**Correspondence with  
Virginia Department of Game  
and Inland Fisheries (VDGIF)**

**From:** Ewing, Amy (DGIF) [Amy.Ewing@dgif.virginia.gov]  
**Sent:** Monday, March 08, 2010 9:37 AM  
**To:** Giglio, Patrick  
**Subject:** ESSLog# 30636\_Potomac Radio\_tower construction  
**Attachments:** USFWS tower recommendations.doc

POTOMC RADIO, CMPT 2009-0002 / SPEX 2009-0029

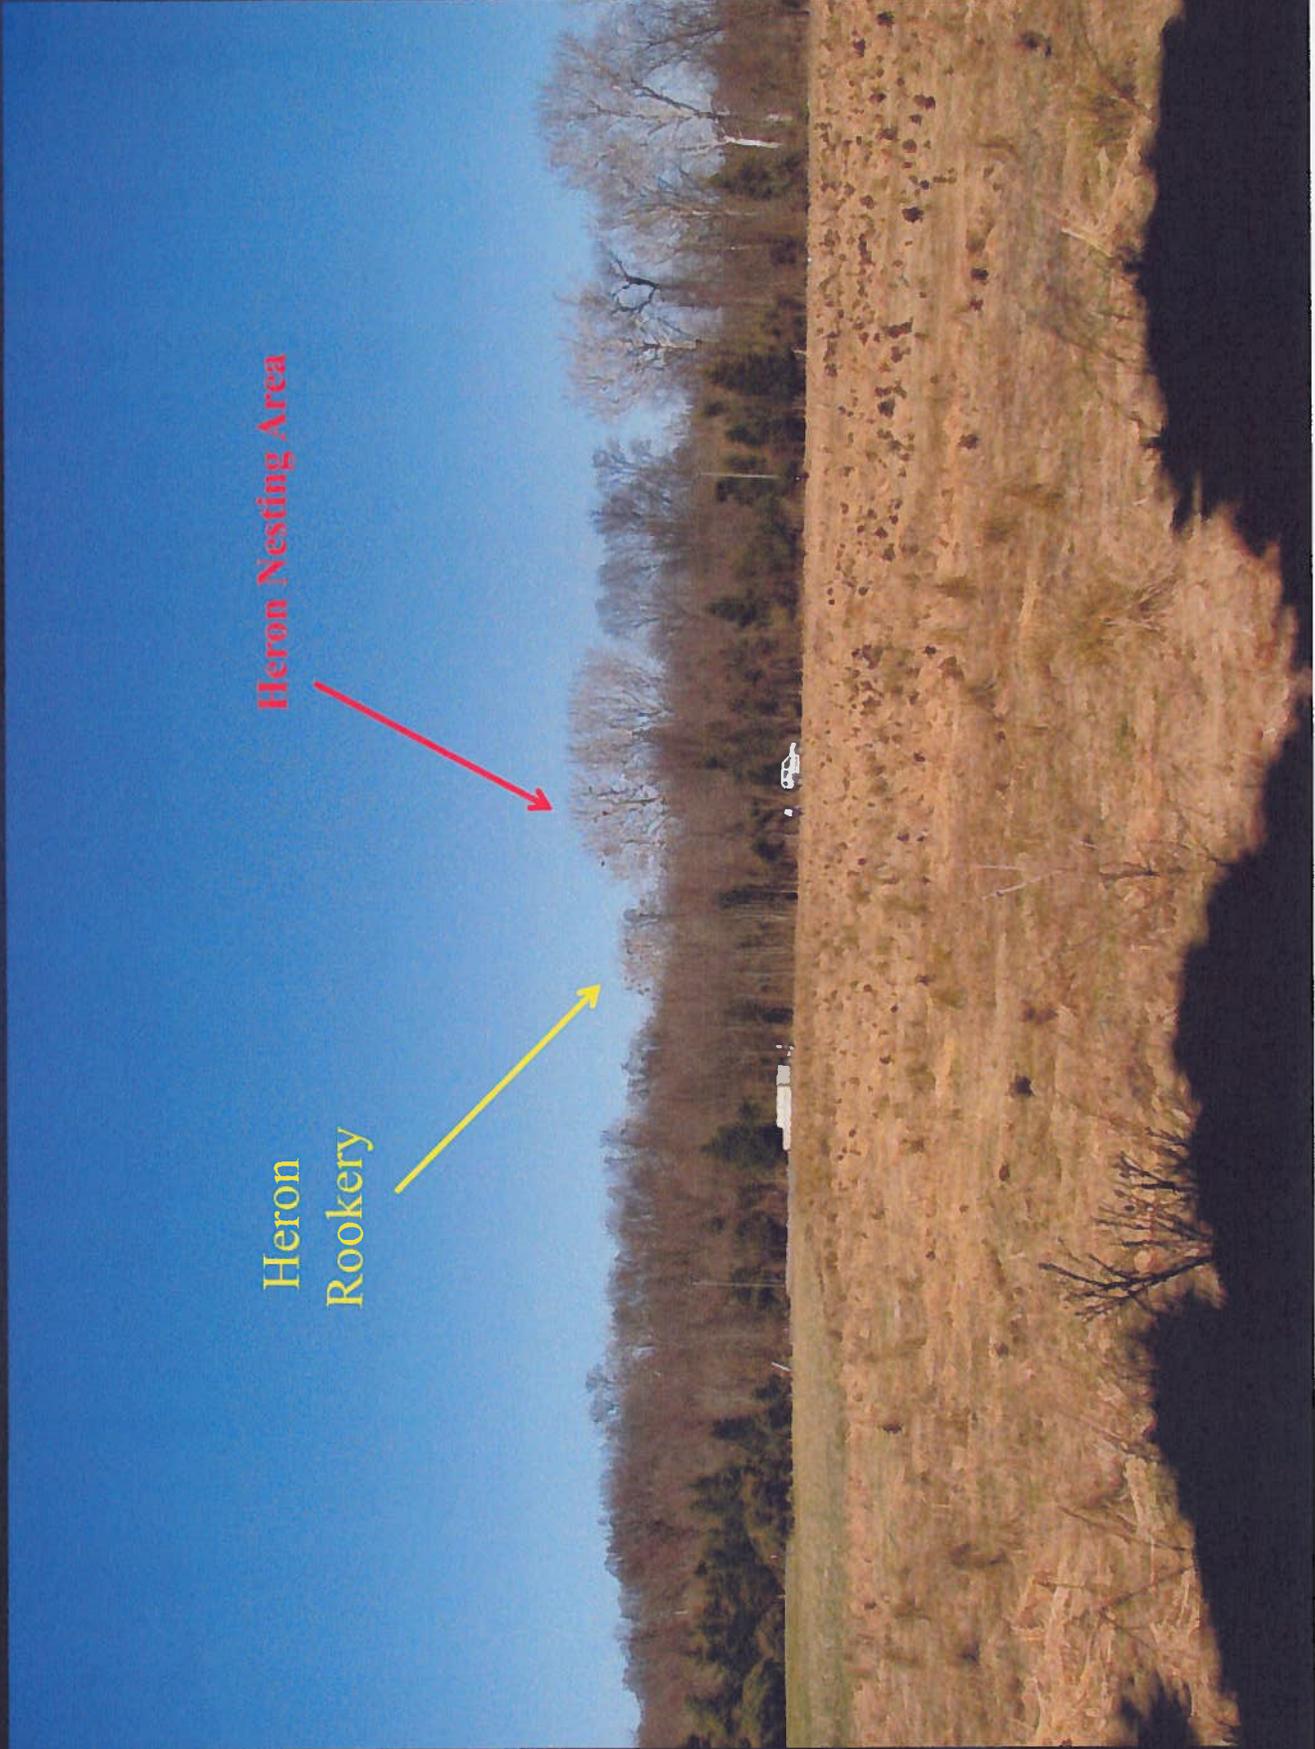
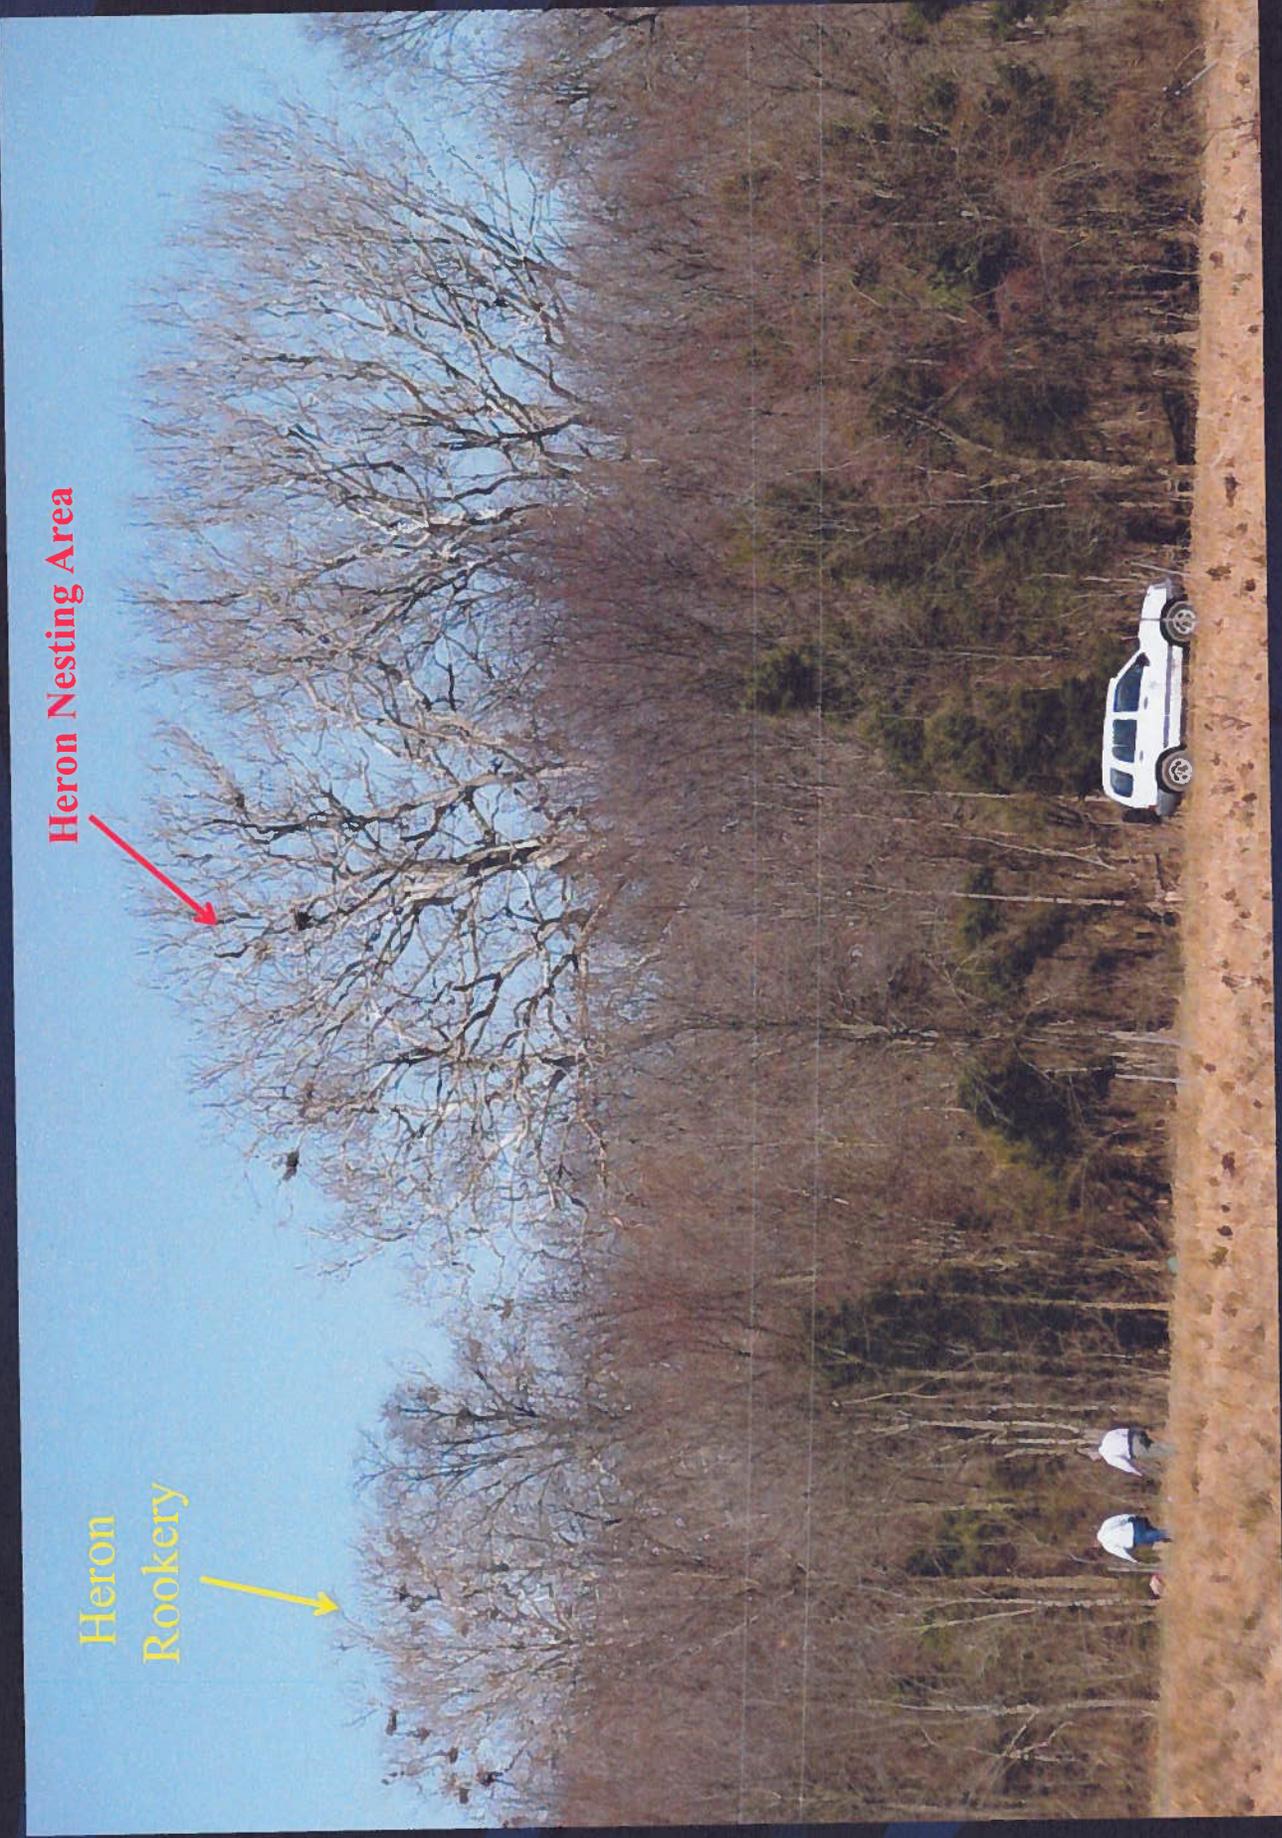
Thank you for your response dated March 8, 2010. During a site visit this week we noted five occupied Blue Heron Nests on the east bank of the Broad Run in two sycamore trees in close proximity to the proposed radio tower site (see map & photos). These five nest are some distance from the main Rookery which is estimated to consist of 40+ nests located further to the north. We believe these nest may have been established during the 2008 or 2009 breeding seasons, so they were not considered by VDGIIF during the review of the Kincora SPEX application. We note that other large sycamore trees exist in proximity to the five occupied Blue Heron Nests and may provide habit for other nesting birds in the future. Enlight of this new information regarding the proximity of the five nests to the proposed radio tower site can you provide additional input regarding potential impacts and mitigation strategies.

Thanks for the information and map. This is very helpful to us in updating our waterbird colony data. We will extend the boundaries of the colony to include the new nesting sites.

- **Maintain an undisturbed, naturally vegetated buffer of at least 500 ft\* around the colony:** It appears that between the new nesting sites and the project site, the vegetation has already been cleared. So, adherence to this recommendation is not possible. Although, we recommend removing as little additional vegetated buffer as possible and consideration of planting the buffer where possible.

- **Adhere to a time of year restriction from February 15 through July 31 for all construction activities within 0.25 mile\* of the rookery:** We recommend that all construction activities, including additional ground clearing, associated with the installation of the towers adhere to this time of year restriction. This serves to protect nesting birds from disturbance allowing them to brood their eggs, feed their young, etc. Once the young have successfully fledged, the construction activities are less likely to interrupt successful reproduction and rearing of young.

**Potomac Radio**

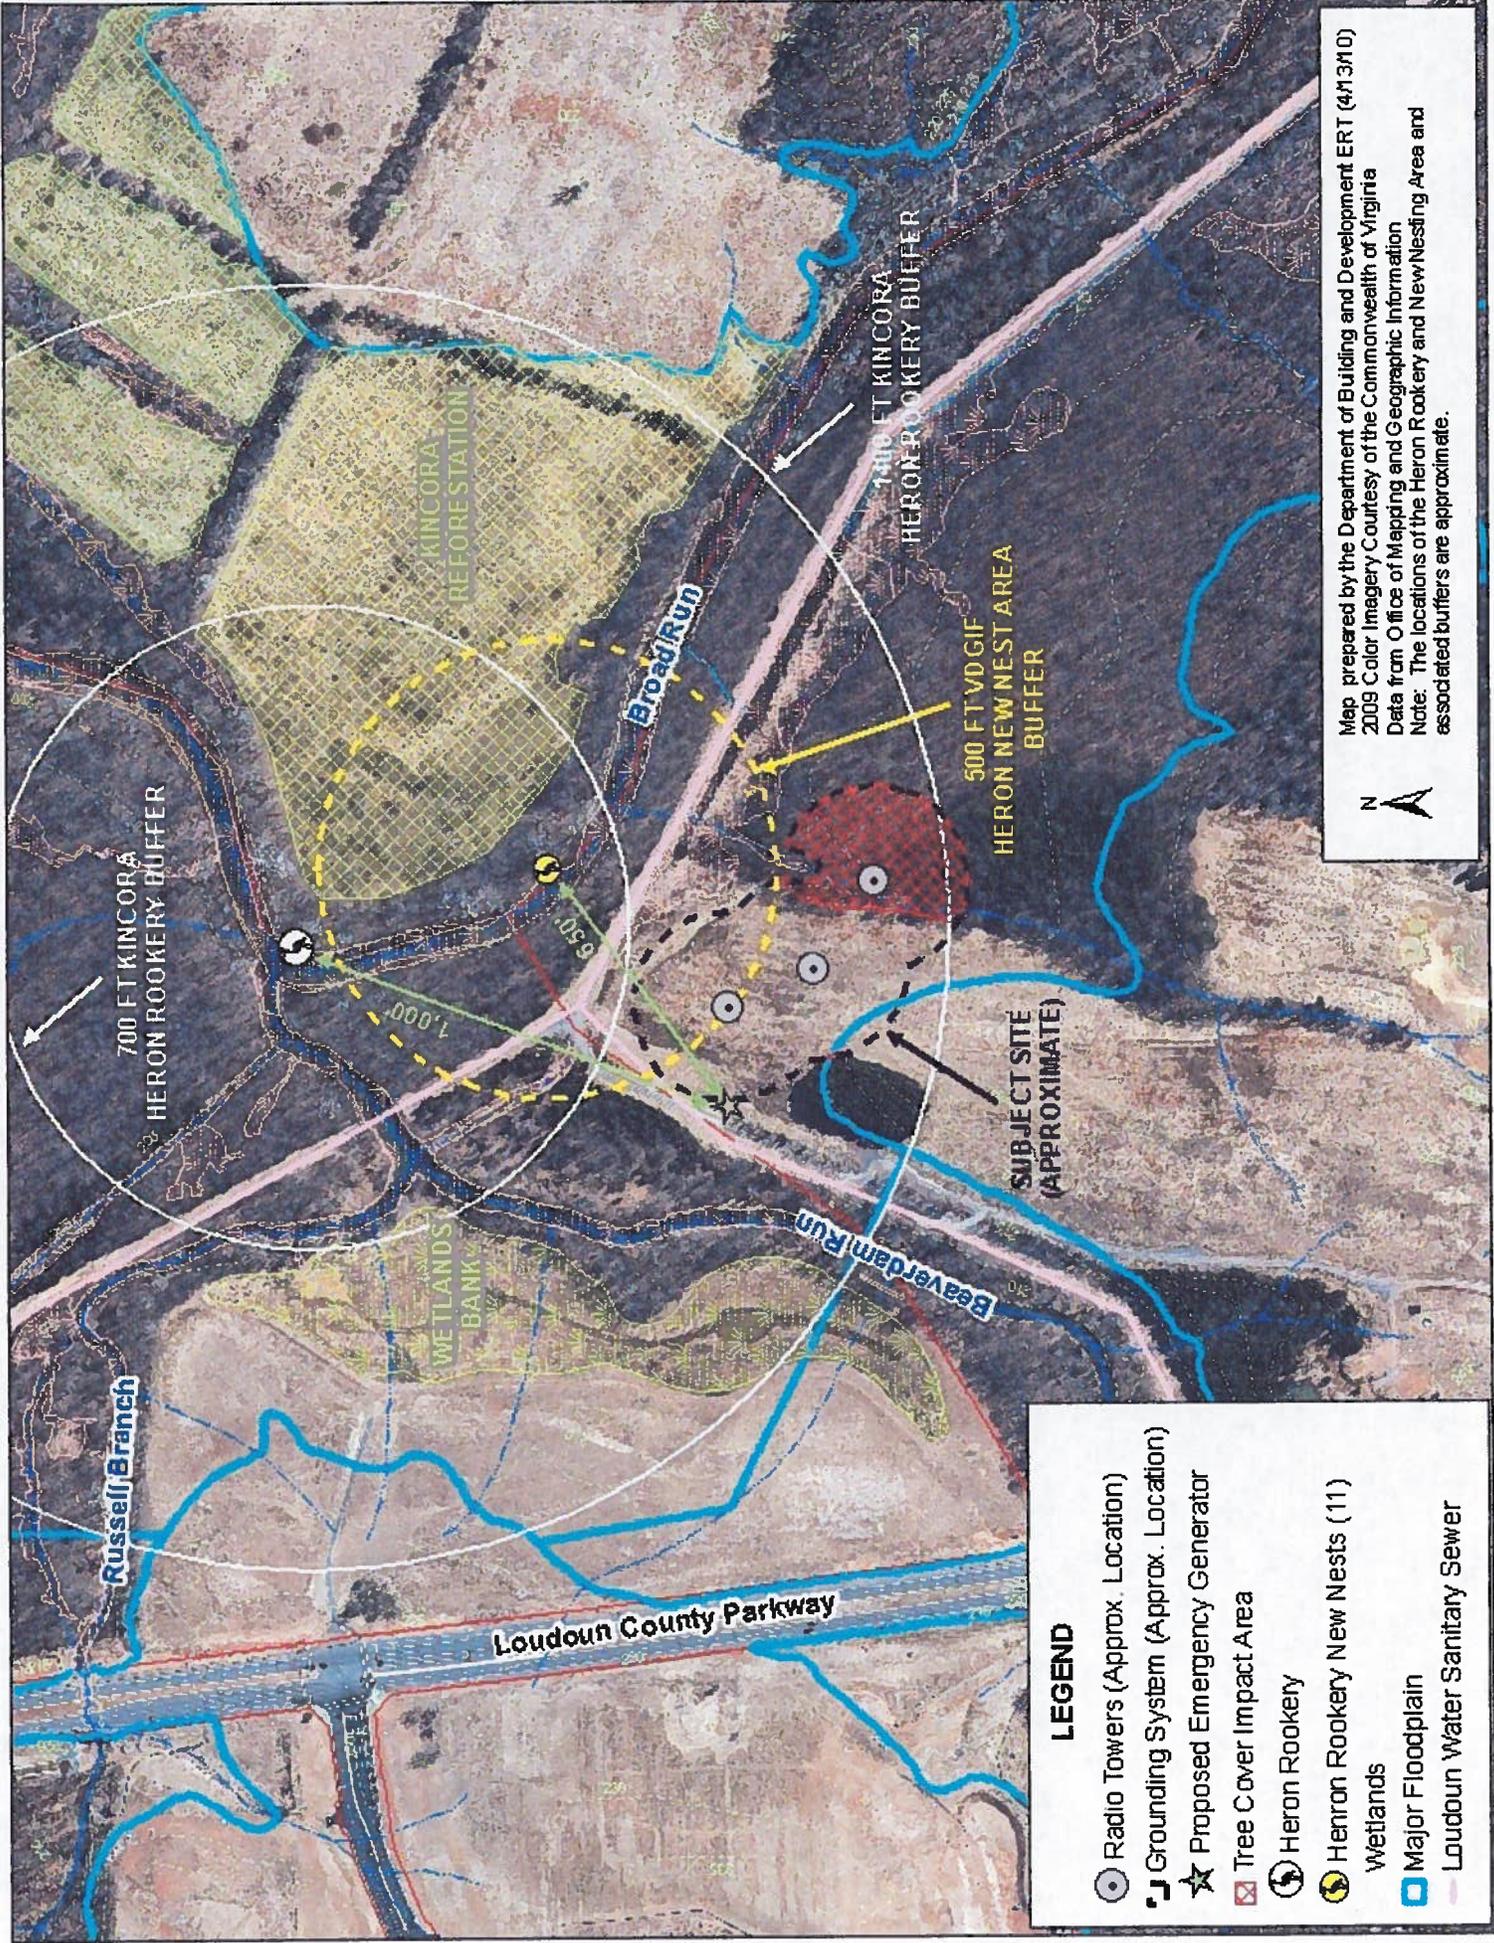
Attached is an updated map depicting the 500 feet undisturbed buffer and location of proposed emergency generator. Also I would like to note that as of last week there is now 11 nesting pairs located in the sycamores adjacent to the subject site. Give me a call if I can provide any additional information.

What type of activities can occur in the 500 ft. "do not disturb" area defined by VDGIF in proximity to the Heron Rookery?

What is the effect of the construction and/or presence of tall structures in proximity to Heron Rookeries based on case studies?

What effect does noise (ie. emergency generator at 70 decibels) have on the Heron Rookery and what are acceptable levels?

What type of activities can occur in the 500 ft. "do not disturb" area defined by VDGIF in proximity to the Heron Rookery? We recommend that a 500-ft undisturbed, naturally vegetated buffer be maintained on the nest. We recommend no disturbance within this buffer during the nesting season and no alterations to this vegetated buffer at any time. The purpose of the buffer is to provide line of sight protection as well as a physical barrier from human disturbance. In addition, it allows for some expanse of the colony if needed.

What is the effect of the construction and/or presence of tall structures in proximity to Heron Rookeries based on case studies? Based on the experience of our bird experts, Jeff Cooper and Sergio Harding, we do not anticipate the presence of the radio towers to negatively impact the heronry. They may actually provide additional substrate for the birds to nest on. More impactful than anything is simply increased urbanization in the area.

What effect does noise (ie. emergency generator at 70 decibels) have on the Heron Rookery and what are acceptable levels? We do not believe the noise from the generator will adversely impact the birds. The level of the noise is really rather small (same as a typical vacuum cleaner or TV) and it will be periodic.
